Technical Service Bulletin: TSB180092

Released Date: 11-Jul-2018

Improved Aftercooler and Intercooler Cores

Figure 1, Top: Manual Weld Malfunction. Bottom: New Robotic Weld.

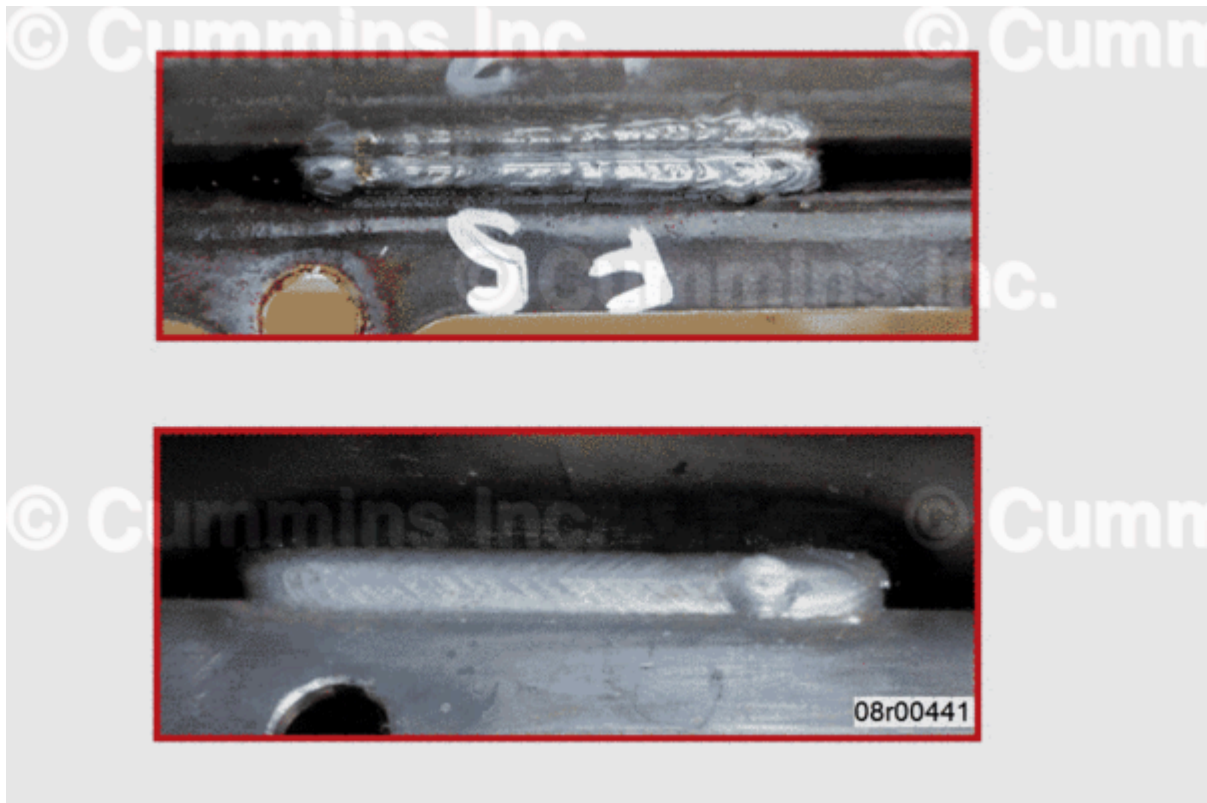
- Aftercooler or intercooler core flange and/or welding malfunction

Update to latest revision of core with more robust design.

Figure 3, Intercooler Core Part Number Identification

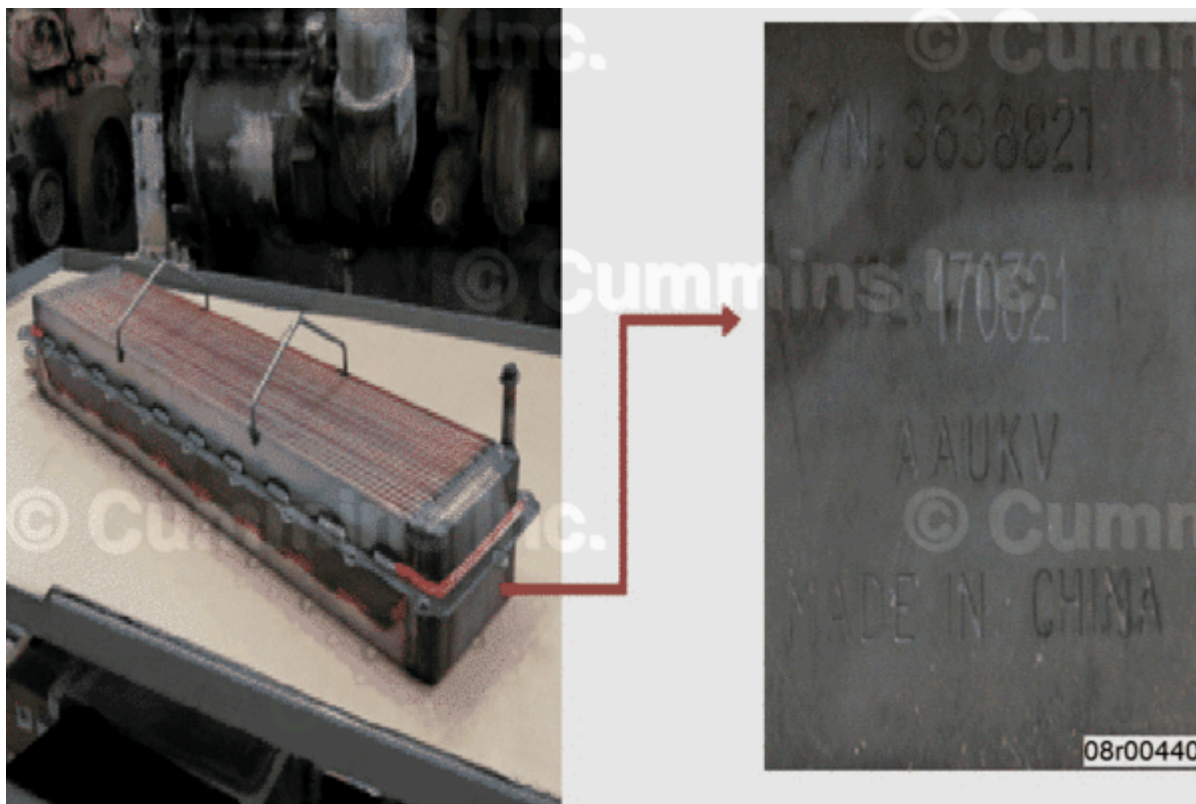
Note : Revision number has been added to intercooler part number after 6 Jul 2018 – date code 180706.

Intercooler and aftercooler cores with a rev number after the part number should be used.
